<b>City of Rocky Mount Addendum 1</b>		
	<b>Refer <u>ALL</u> Inquiries regarding this RFP to:</b> Chynice Chapman Purchasing Manager	<b>RFLOI # 320-050222CC Pedestrian Signals EB-5711</b>	
		<b>RFLOI Due Date: 03/25/2022</b>	
	<b>Contract Type: A&amp;E</b>

RFLOI PED SIGNALS  
EB-5711  
CITY OF ROCKY MOUNT  
NASH COUNTY NORTH CAROLINA

SHEET TITLE:  
VISUAL FOR  
RFLOI

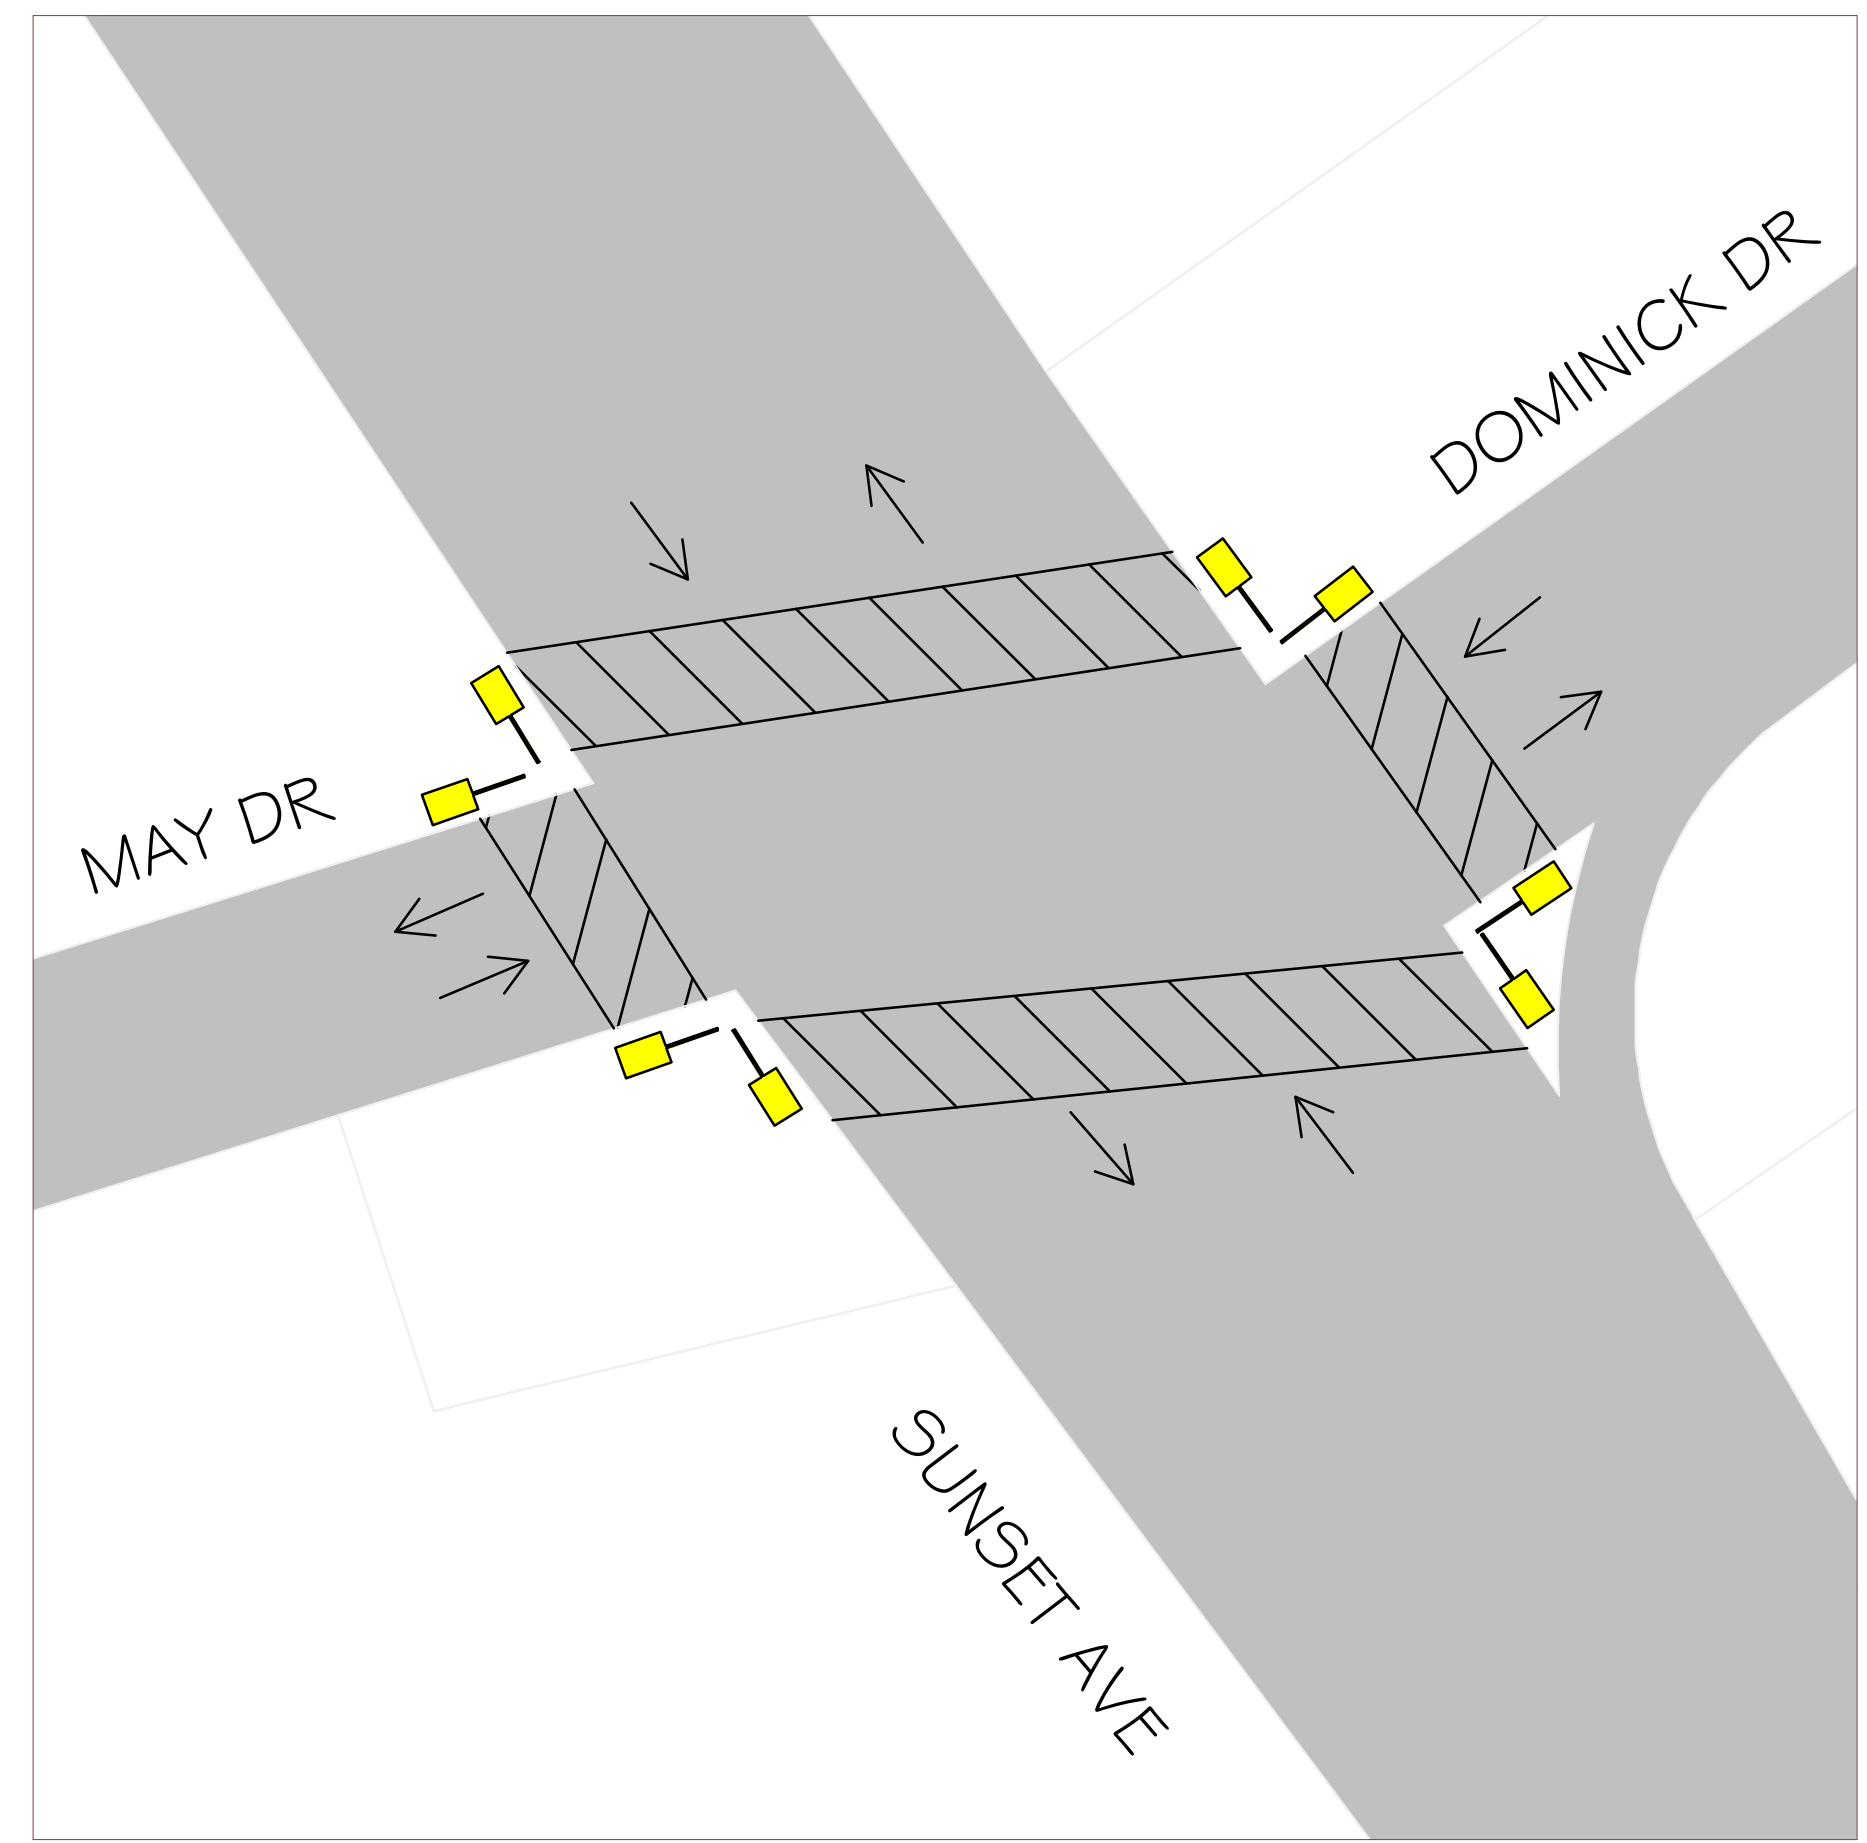
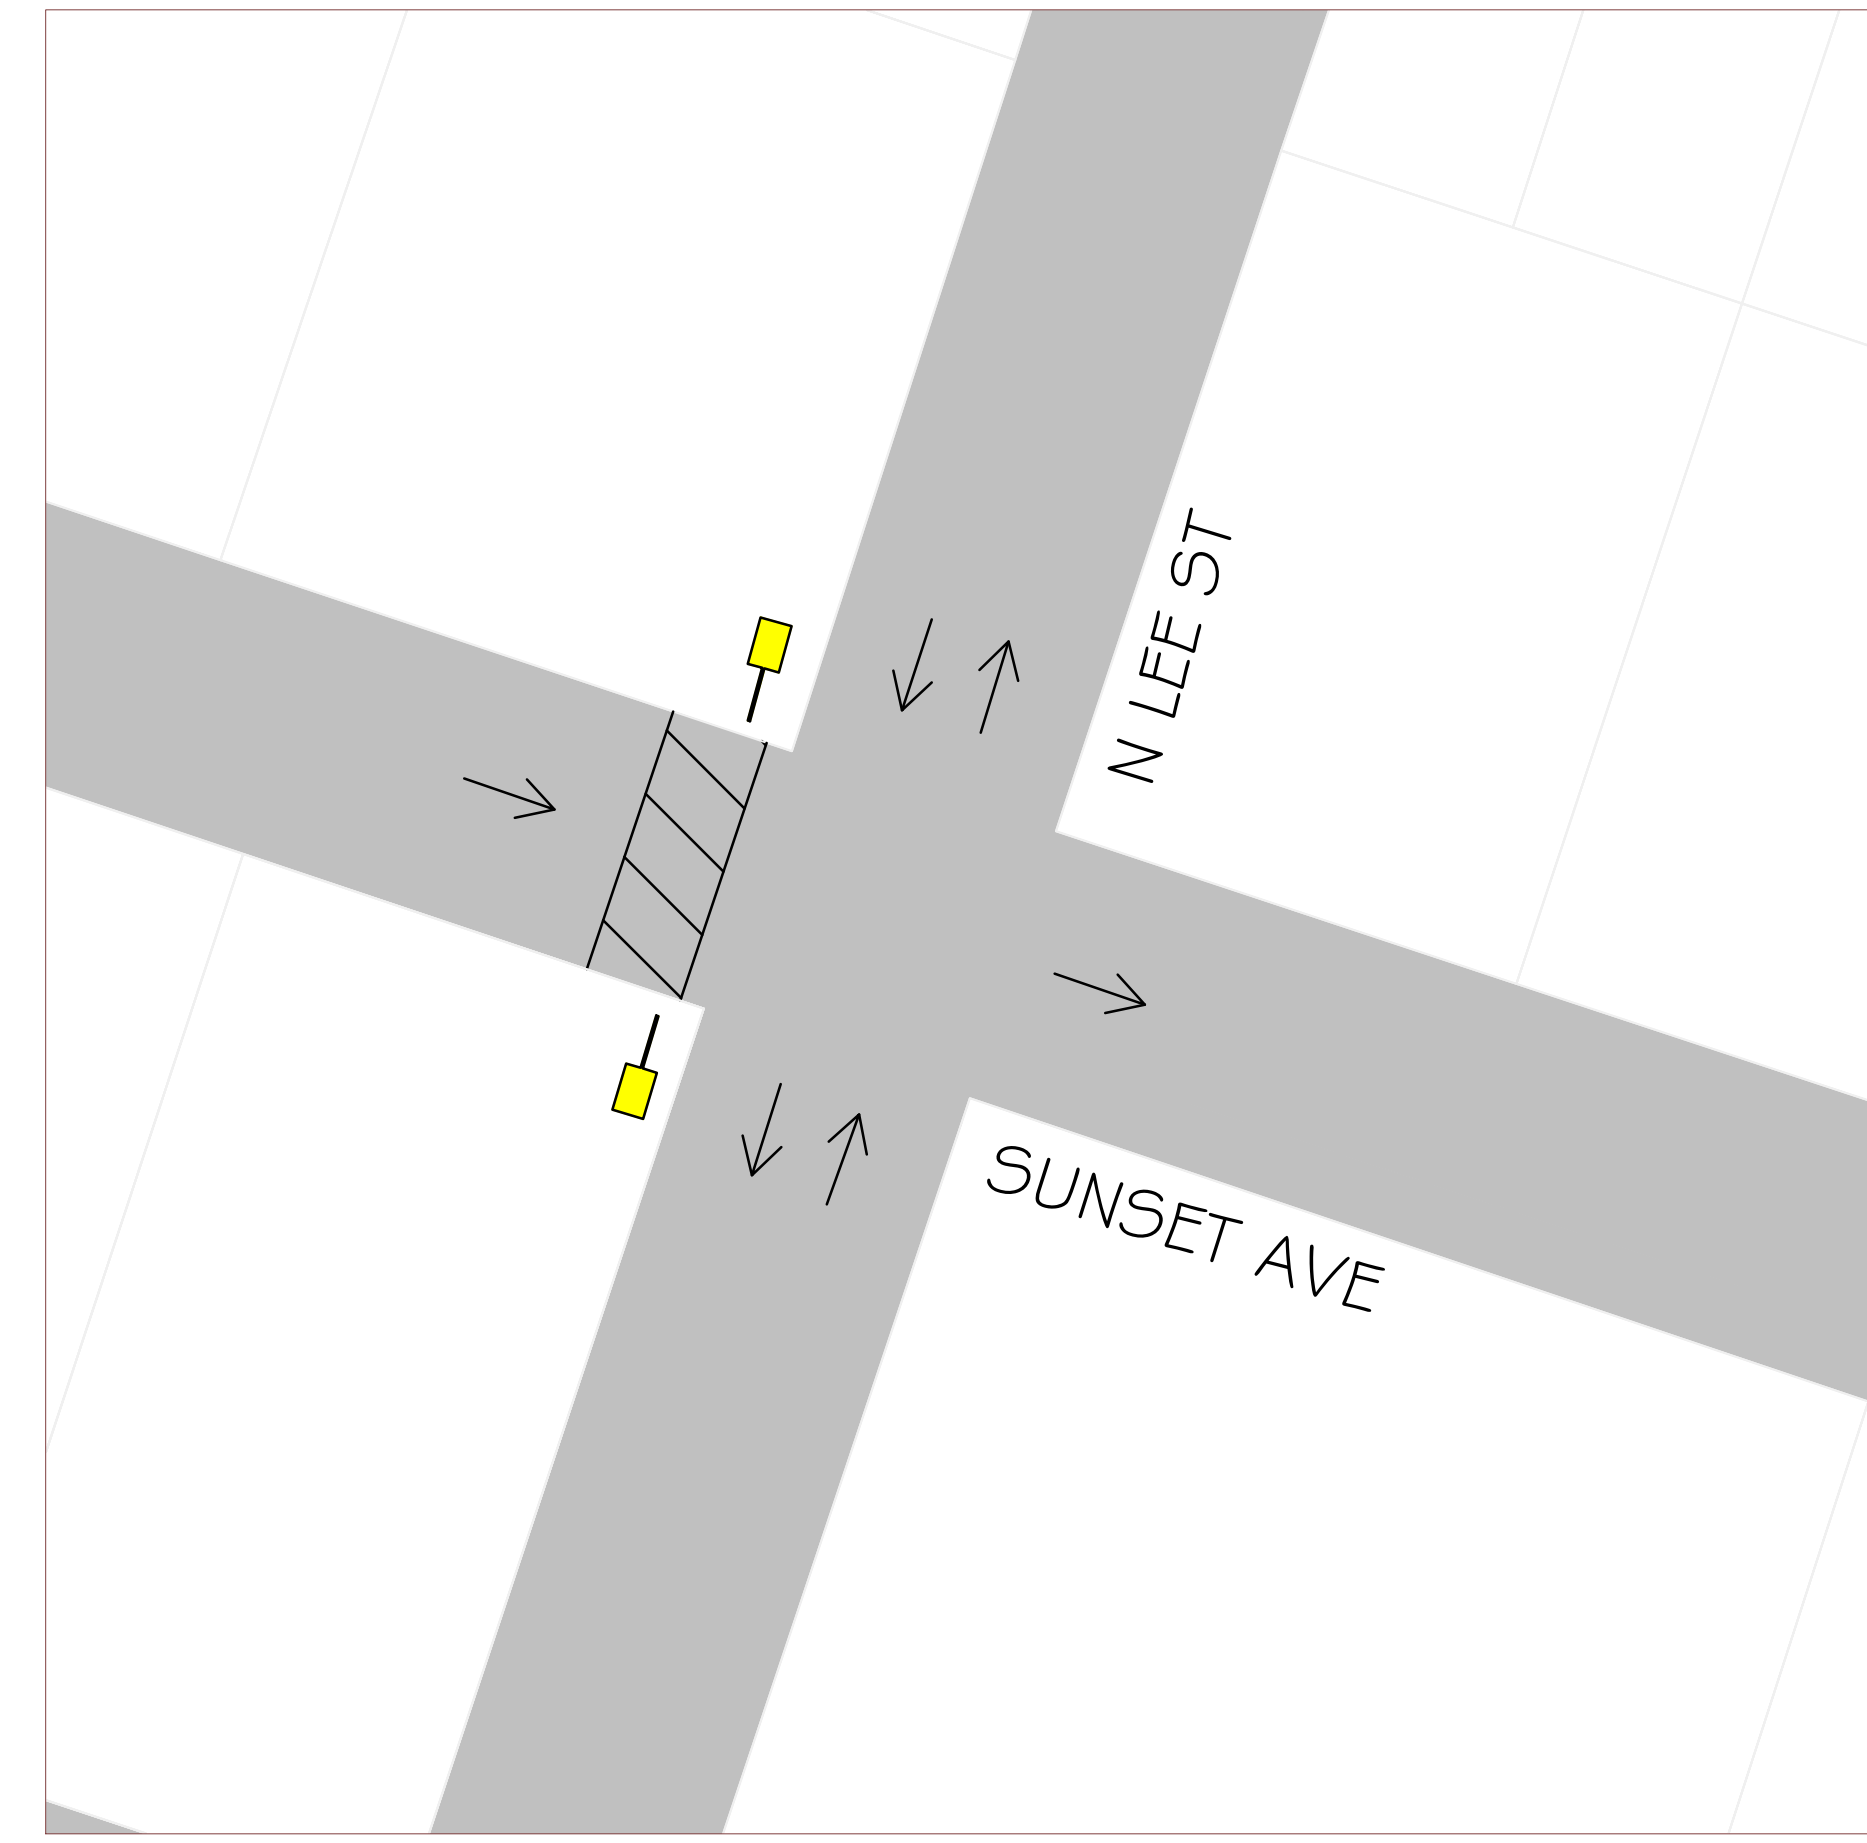
2. **Question:** Are only existing crosswalks to be signalized or does the city anticipate adding new crosswalks to be signalized as part of this project?

Lee street and Pine Street only require one cross walk and pedestrian signal over Sunset Avenue. May Drive, Grace Street, and Franklin Street require crosswalks and pedestrian signals at all four legs of the intersections. See attached sketch for more details.

1. MAY DR: 4 CROSSWALKS, 4 PED SIGNAL PAIRS
2. LEE ST: 1 CROSSWALK, 1 PED SIGNAL PAIR
3. PINE ST: 1 CROSSWALK, 1 PED SIGNAL PAIR
4. GRACE ST: 4 CROSSWALKS, 4 PED SIGNAL PAIRS
5. FRANKLIN ST: 4 CROSSWALKS, 4 PED SIGNAL PAIRS
